PHASE II REMEDIAL INVESTIGATION

**INSTALLATION RESTORATION STUDY
NAVAL SUBMARINE BASE - NEW LONDON
GROTON, CONNECTICUT**

RE: Phase II Remedial Investigation
Atlantic Project No.: 1256-18

**NAVY RESPONSES TO EPA COMMENTS (MAY 5, 1993)
ON THE REVISED DRAFT PHASE II
REMEDIAL INVESTIGATION WORK PLAN (MARCH 1993)**

FIGURE 7-5
FIELD SAMPLING PLAN
GOSS COVE LANDFILL

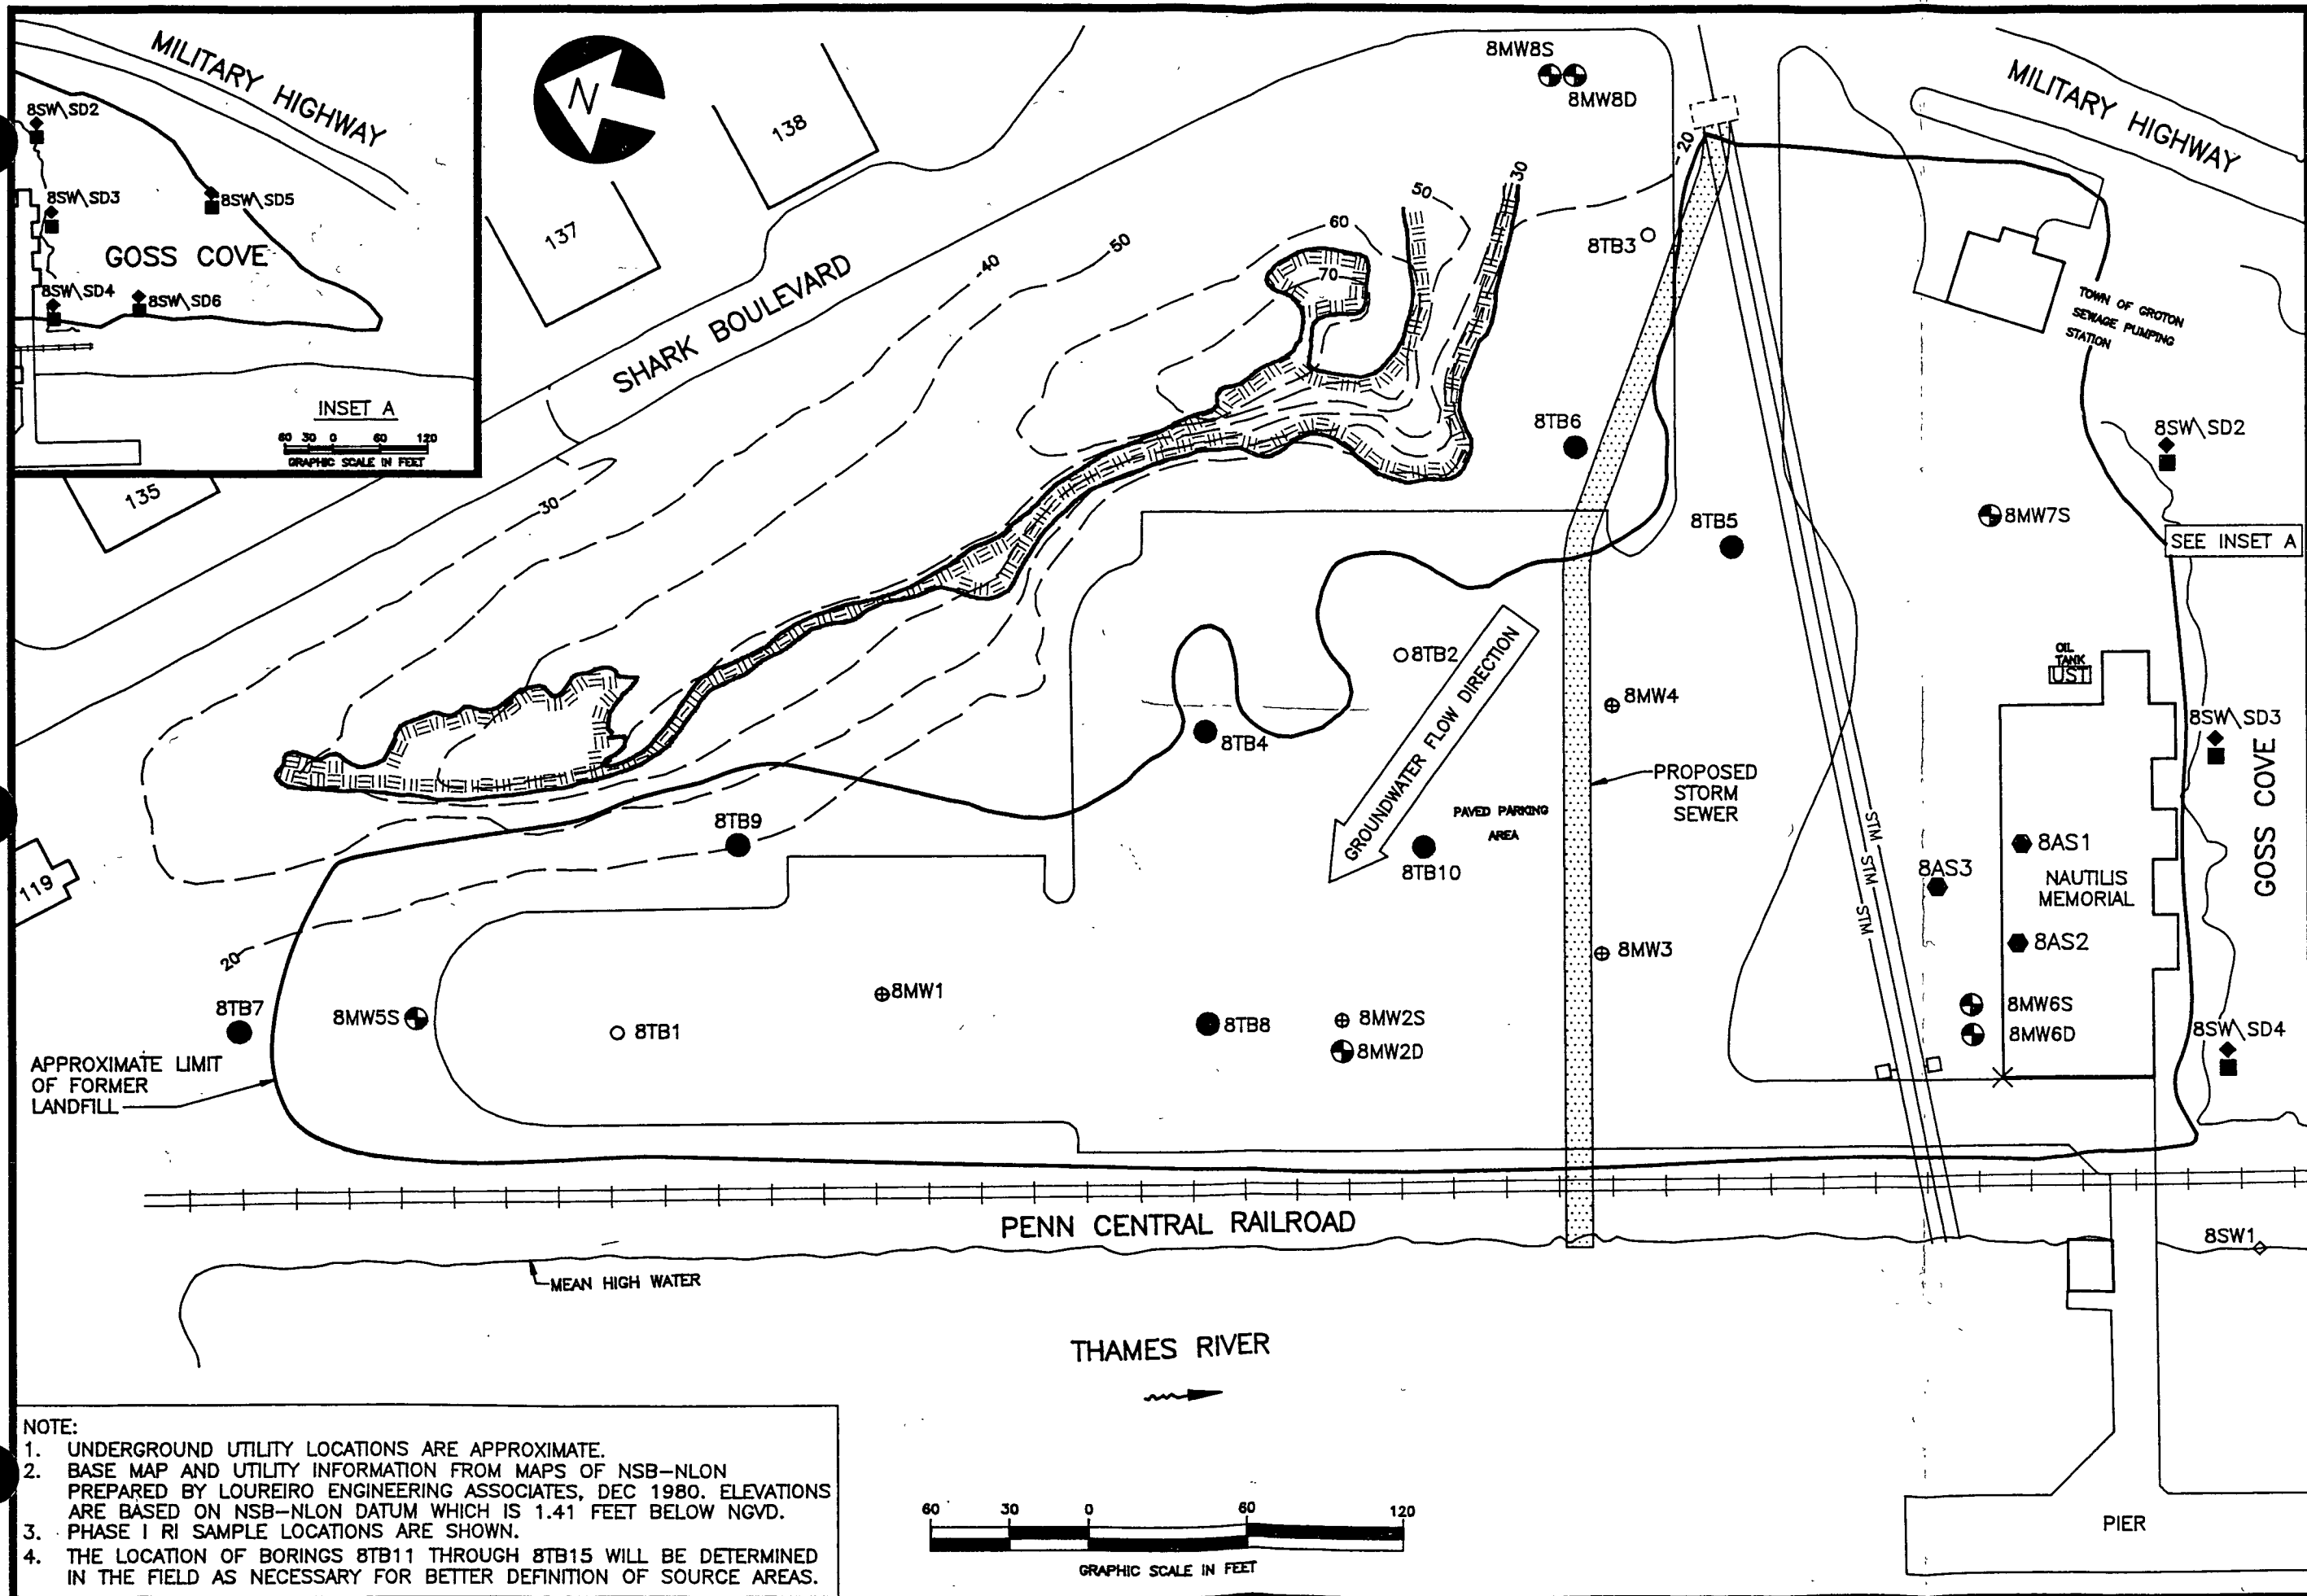
20. Page 198, Figure 7-5 — Field Sampling Plan, Goss Cove Landfill

the bank of the Thames River north and upstream of the pier, yet south and downstream of the storm drain outfall from the ball fields. The Goss Cove Landfill Field Sampling Plan does not show this sample location. If the location described is the location requested, this sample location should be indicated in Figure 7-5.

56. **Figure 7-5 - Goss Cove Landfill, Field Sampling (Page 154)**

No sample location is visible on the Goss Cove map (Figure 7-5, page 154 in the Field Sampling Plan) in the Thames River immediately north of the proposed location. This specific sampling location (north and upstream of the pier, yet south and downstream of the storm drain outfall) is of concern to EPA, as this area is suspected of potential discharges.

The reference in this section of the report has been clarified to indicate that all sediment sample locations in the Thames River are shown in Figure 5-3 and listed in Table 5-2.

FIGURE 7-7

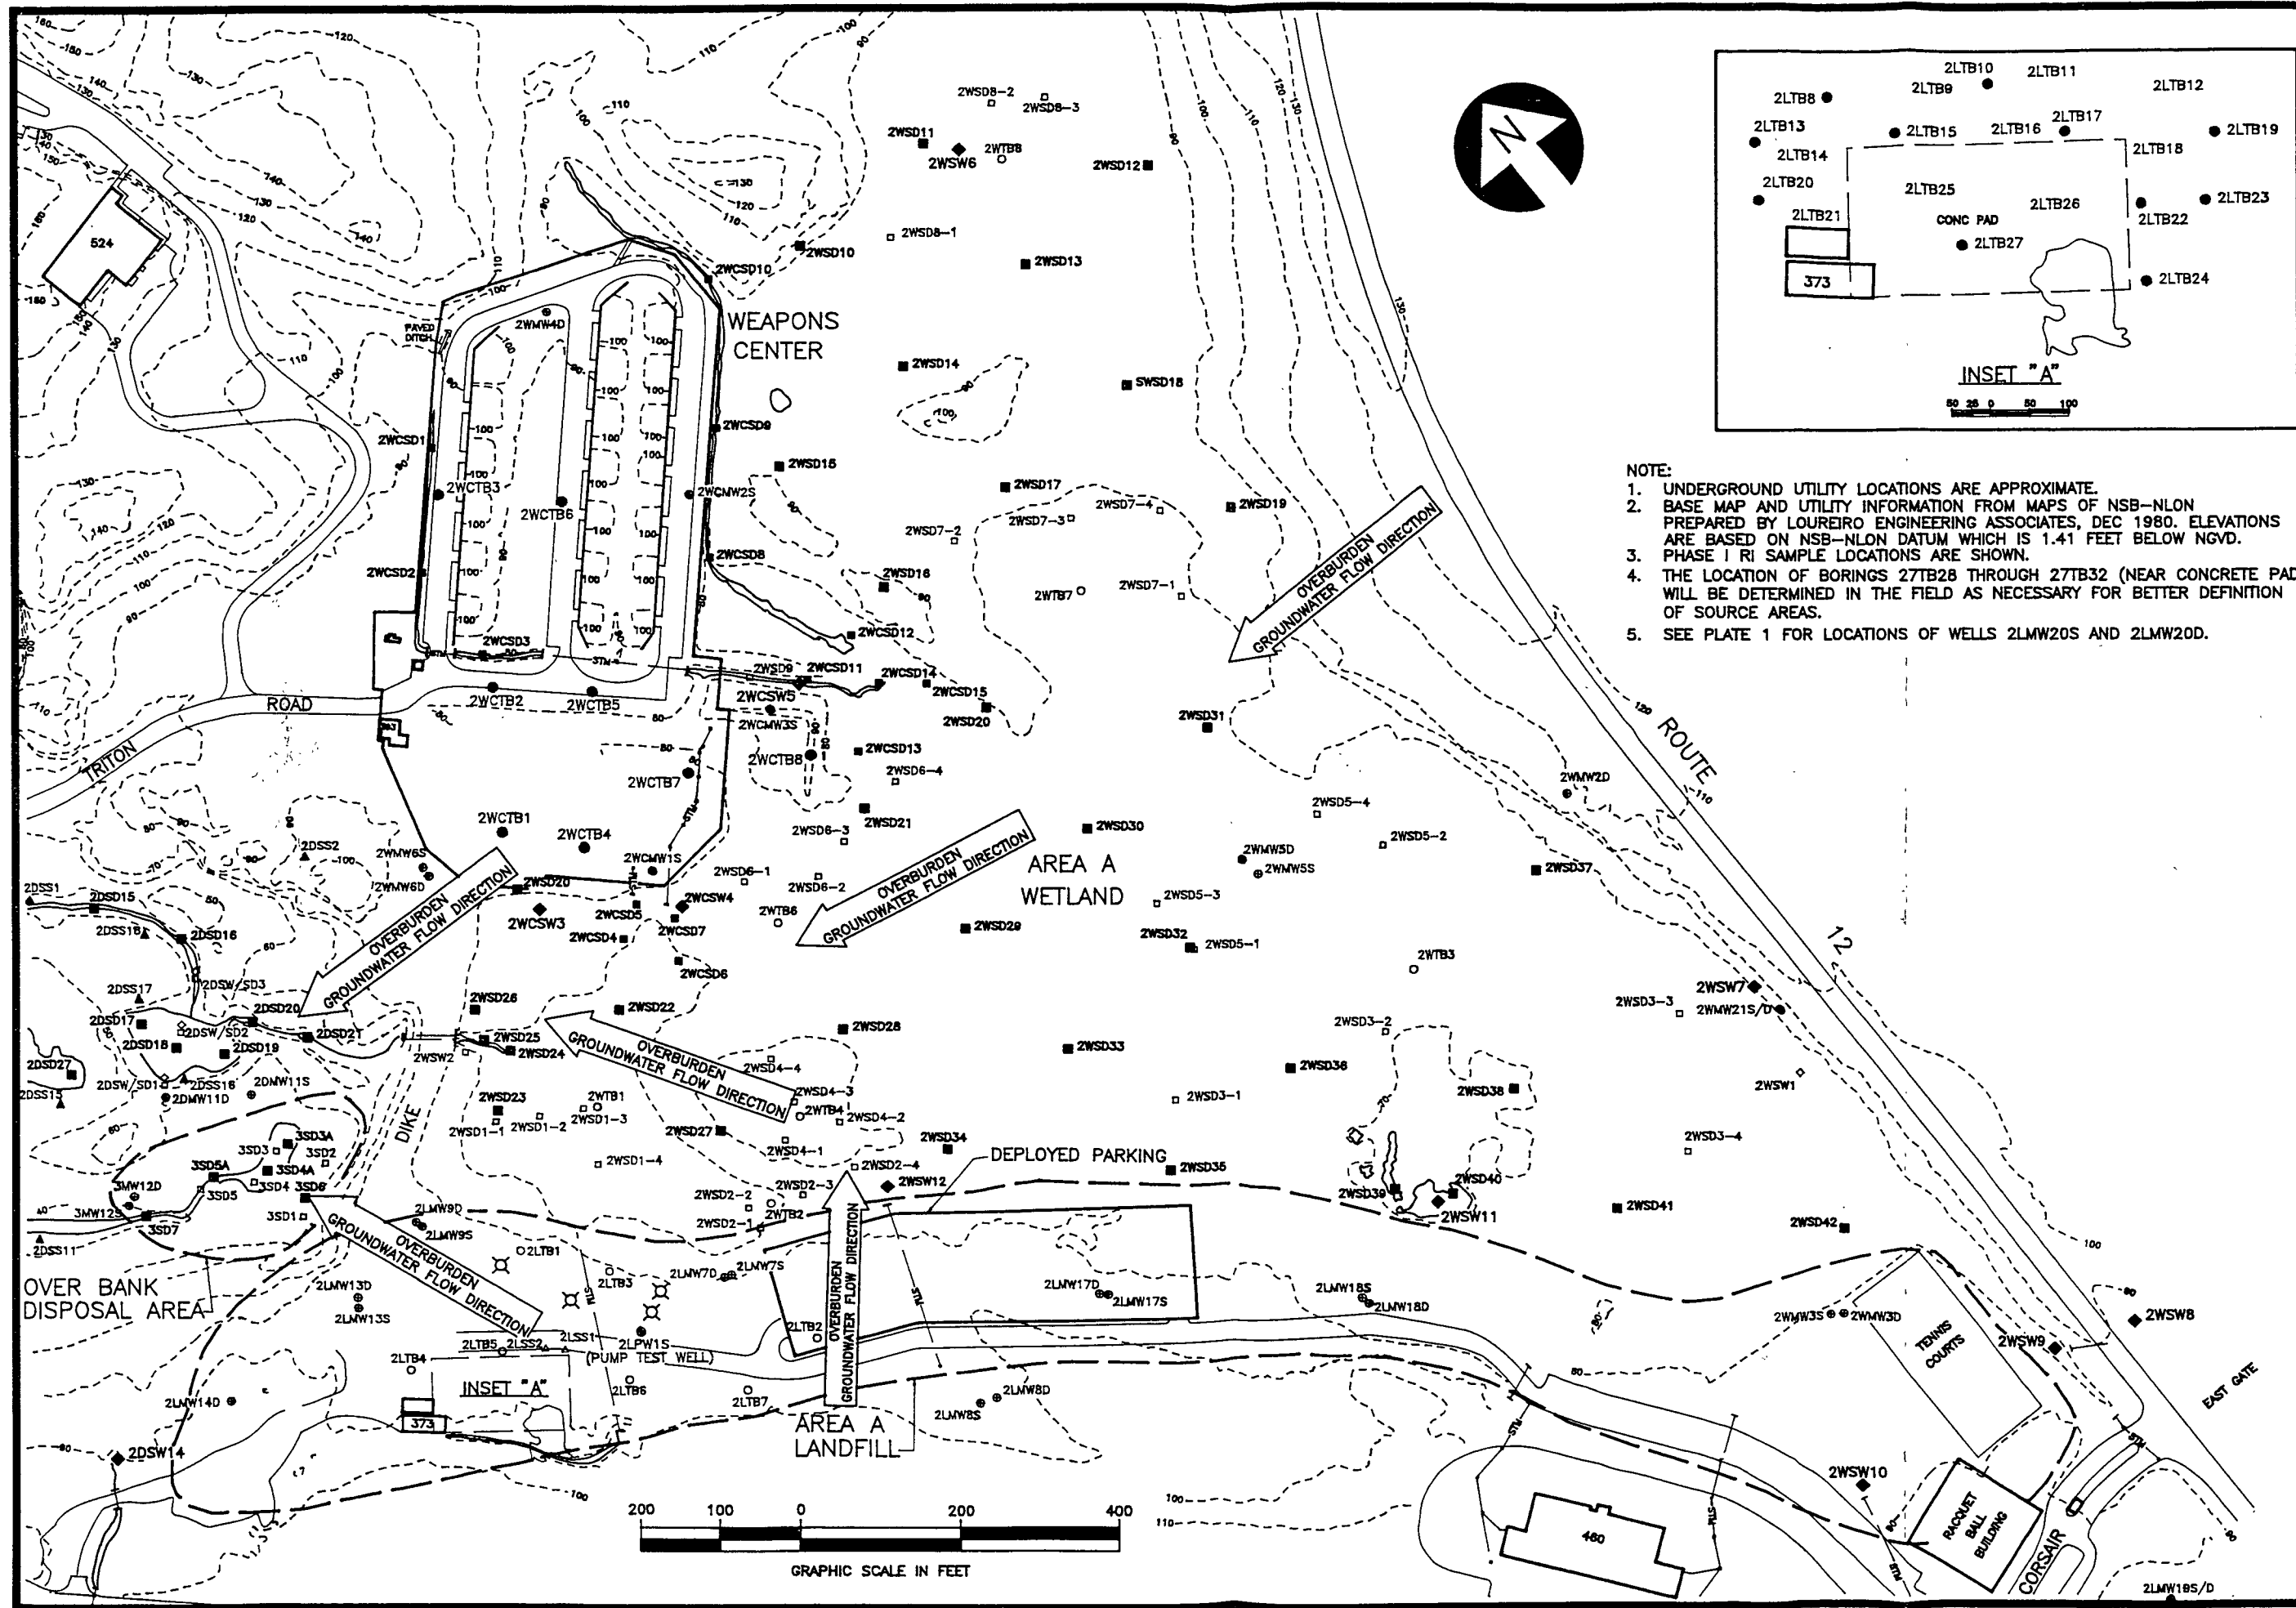
63. **Figure 7-7 - Area A Landfill, Wetland and Weapons Center, Field Sampling Plan (Page 173)**

FIGURE 7-9
FIELD SAMPLING PLAN
DRMO

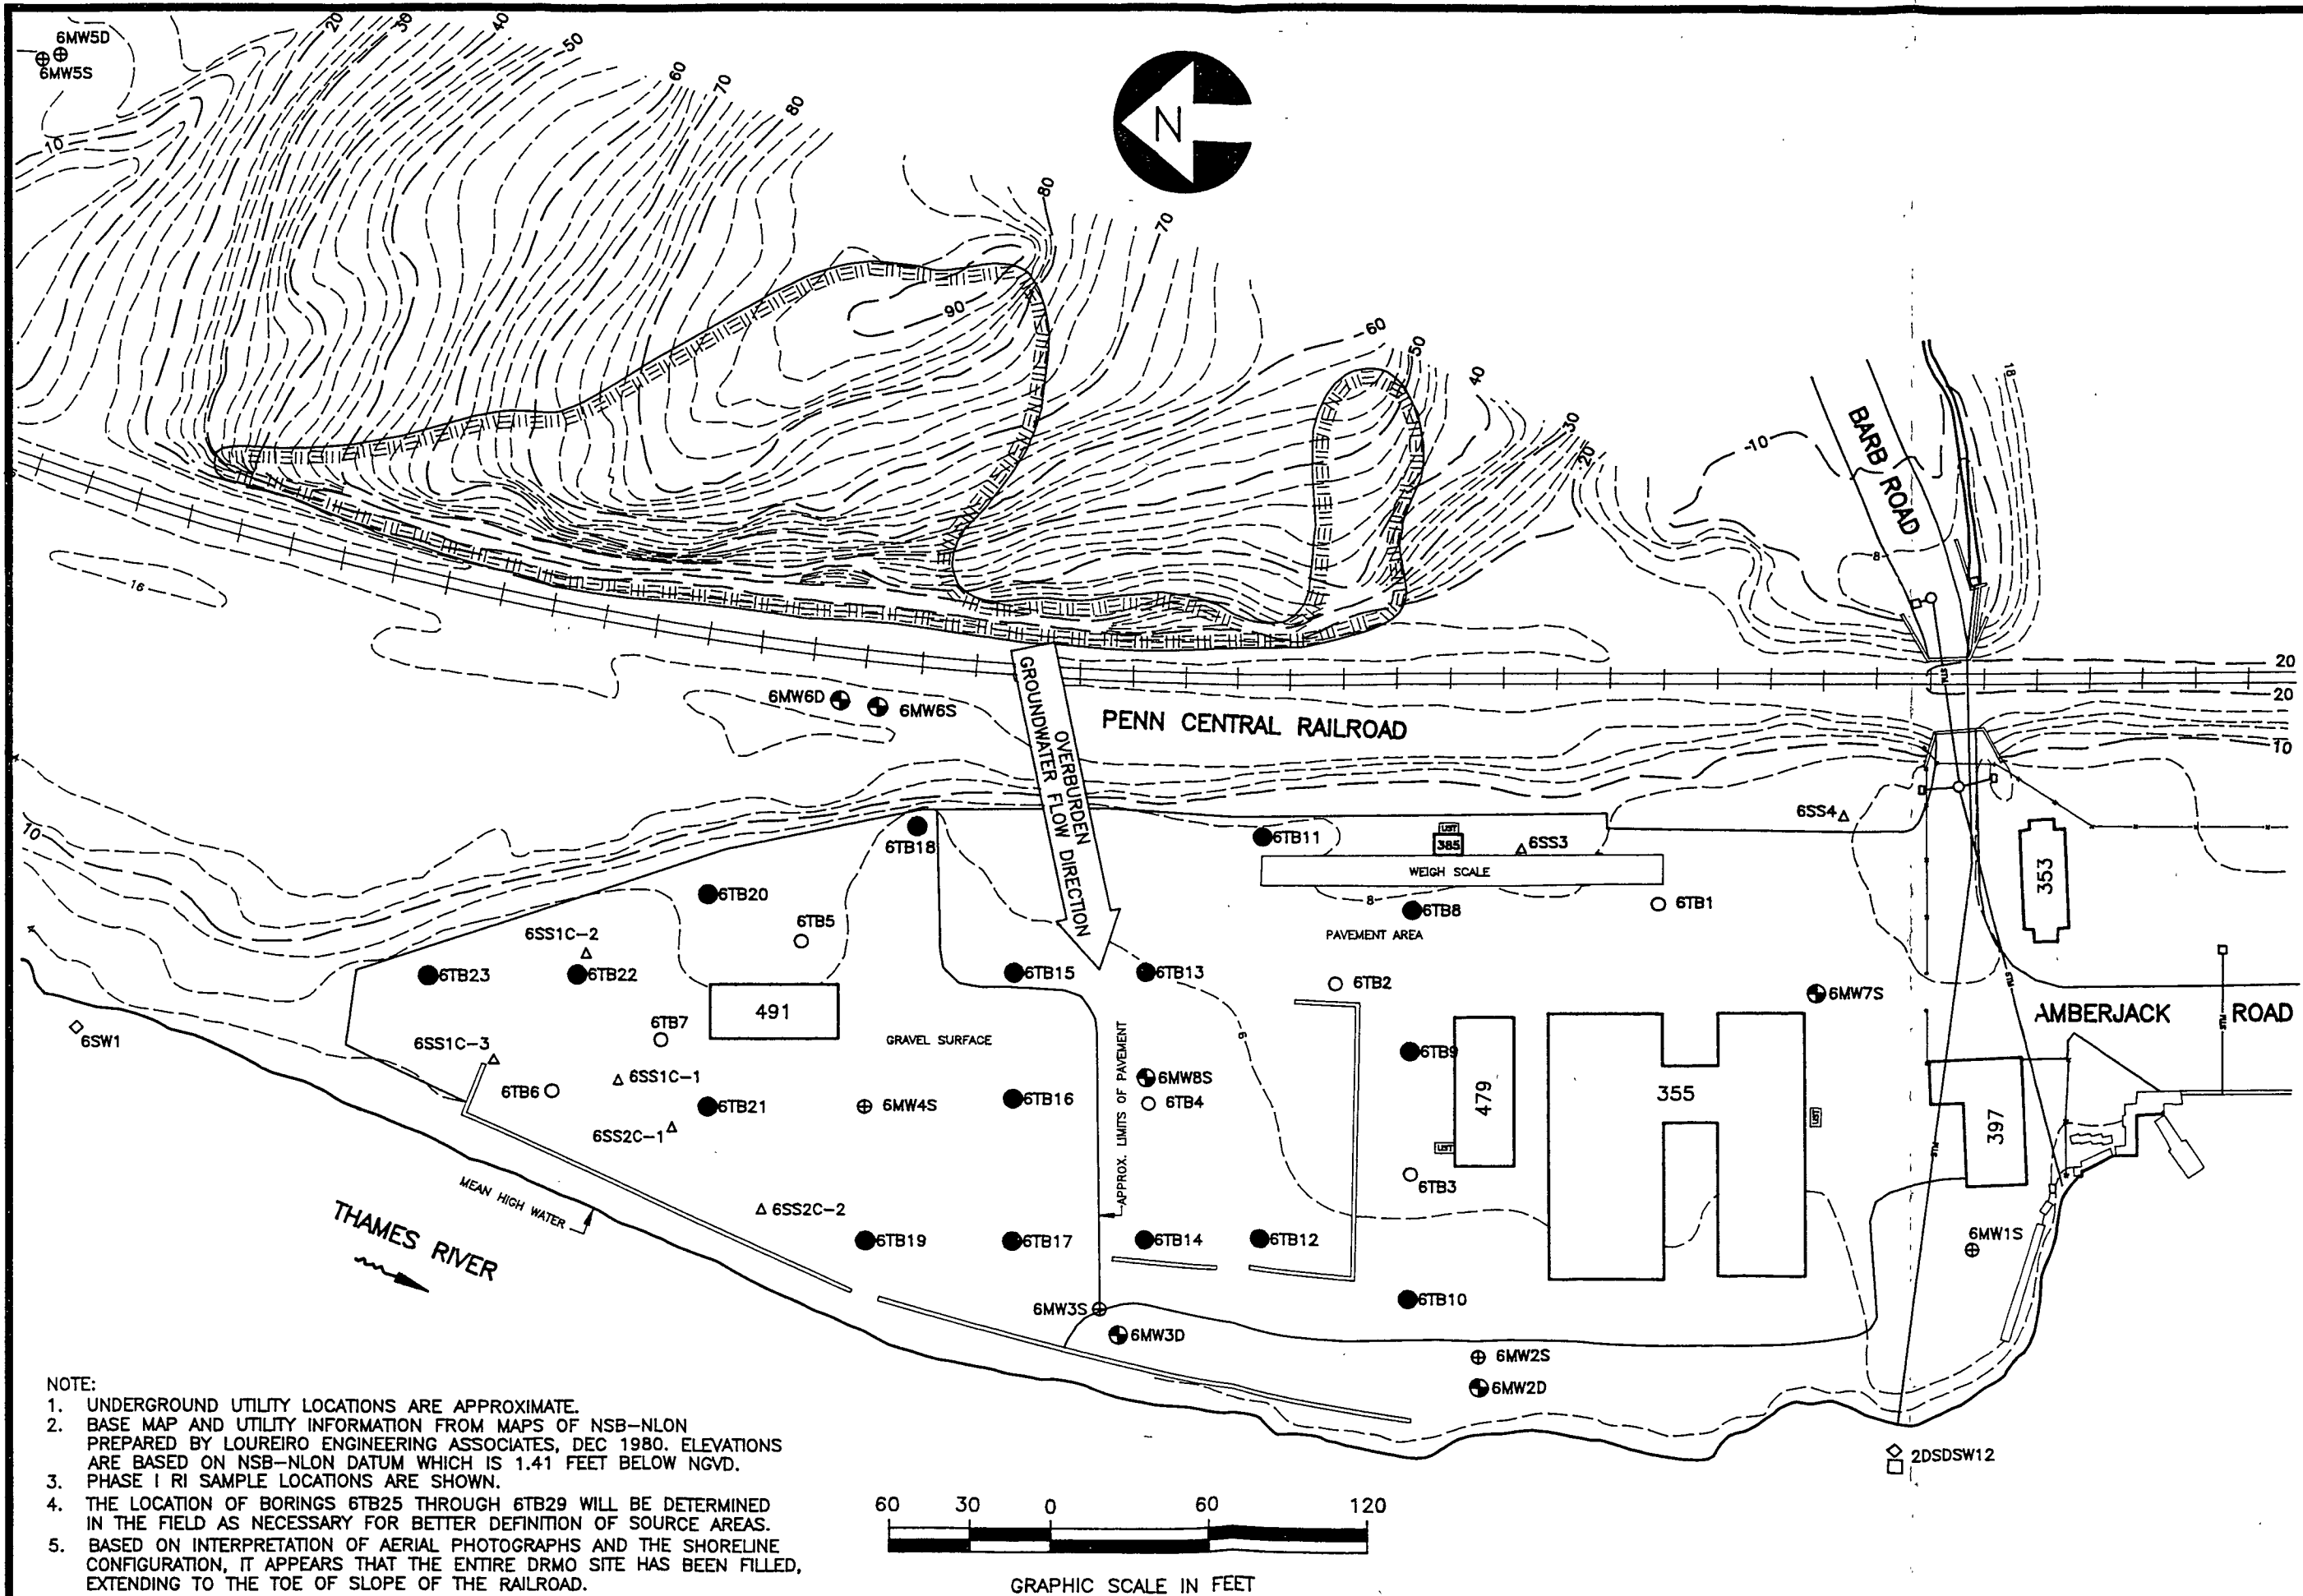
66. **Figure 7-9 - DRMO, Field Sampling Plan (Page 180)**
